**Re: Crown-Indigenous Relations and Northern Affairs Canada Review Comments
for the Issued for Construction Drawings Submission for the Mine Site
Landfarm at the Mary River Project, Water Licence No. 2AM-MRY1325 –
Amendment No. 1**

**Subject: Crown-Indigenous Relations and Northern Affairs Canada Review
Comments for the Issued for Construction Drawings Submission for the
Mine Site Landfarm at the Mary River Project, Water Licence No. 2AM-
MRY1325 – Amendment No. 1**

Document Title	Author, File No., Date
Letter to the Nunavut Water Board Re: Issued for Construction Drawings Submission - Mine Site Landfarm Mary River Project - Type 'A' Water Licence 2AM-MRY1325 - Amend. No. 1	Christopher Murray, Baffinland Iron Mines Corporation, 2020-06-17
Attachment 1: Design Brief & For-Construction Drawings	Knight Piésold Consulting Ltd., NB102-00181/57-A.01, 2020-03-16

Figure 1: Screen Capture of Drawing 100, Rev 0 – Landfill Expansion – Site Plan

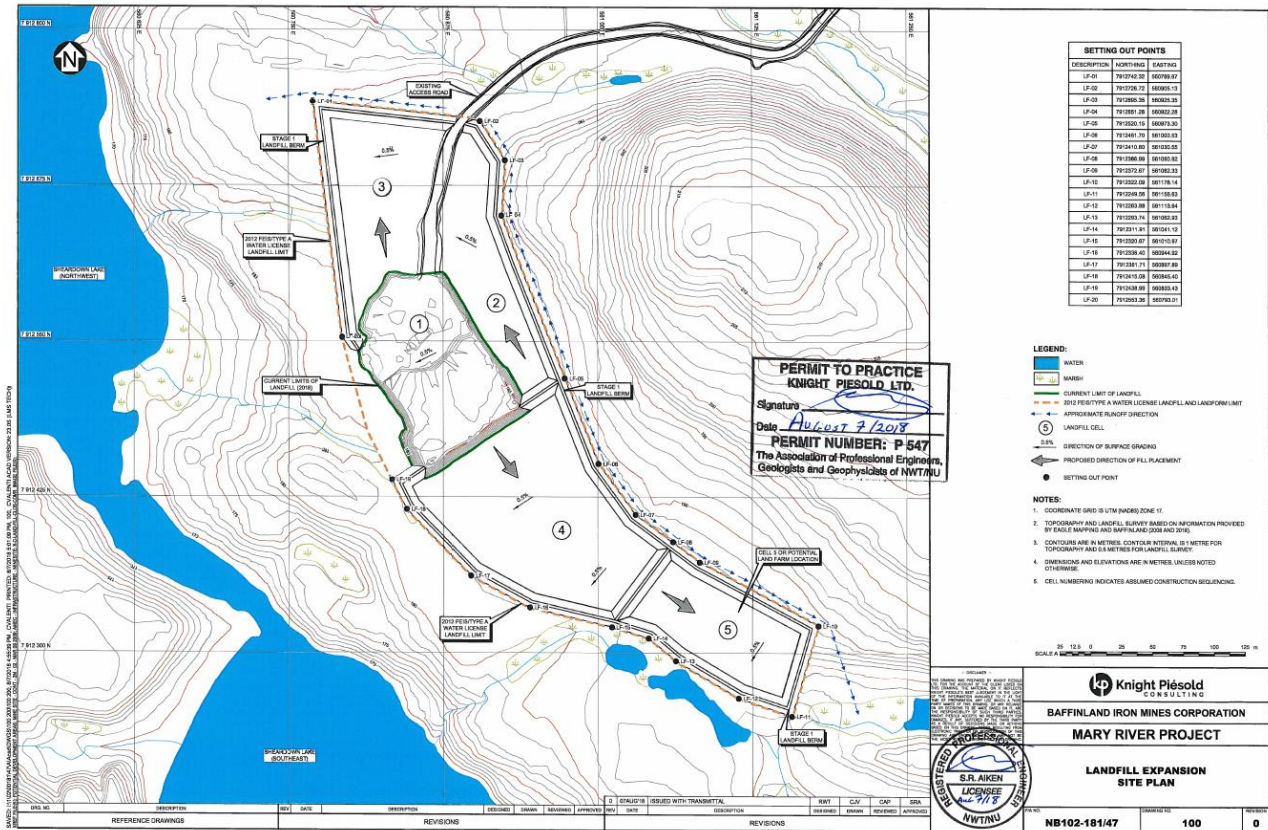
Baffinland Iron Mines Corporation notes that the landfarm location has been altered from its original design. According to the application for Modification No. 10 (BIMC, 2018) *Drawing 100, Rev 0 – Landfill Expansion – Site Plan*, the landfarm was originally planned to be built in what was called cell 5. The Design Brief and For-Construction Drawings show the new location of the landfarm in what the application for Modification No. 10 refers to as Cell 3 (see Figure 1 for screen capture of Drawing 100, Rev 0 – Landfill Expansion – Site Plan).

The reasons for this change were stated by BIMC as follows: “Detailed design identified that the grades in the original location identified in the Modification No. 10 submission would not be appropriate.”

It is not clear whether the area of Cell 5 has also been deemed not appropriate for landfill construction. Further, now that the extents of the landfarm will be changed and the original Cell 3 of the landfill will be used for the landfarm, it is not clear what the implications will be for the capacity and physical extents of the landfill.

(R-01) CIRNAC recommends that BIMC clarify the effects or implications that the change in landfarm location will have on landfill footprint and capacity.
